Access Compliance Report

Public Rights-of-Way

(Curb Ramps)

Intersection ID: 10012781	Main Street: ARNOLD_DR	Cross Street: N/A	Location: SE
ADA ID: B576C22B73AE	Ramp Type: PerpDiag	Initial Pass/Fail: Fail	Overall Compliance: No
		Severity Score: 35

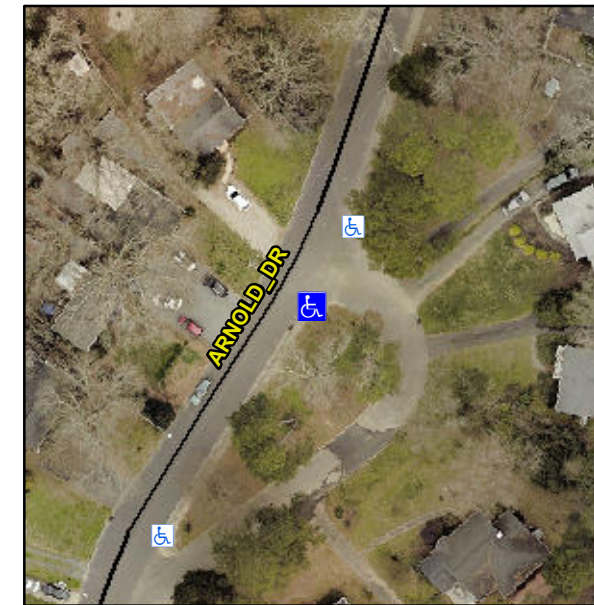
Not Found, R304.5.1

Possible Solutions:

Remove & Replace Curb Ramp With Two New Directional Ramps or Equivalent.
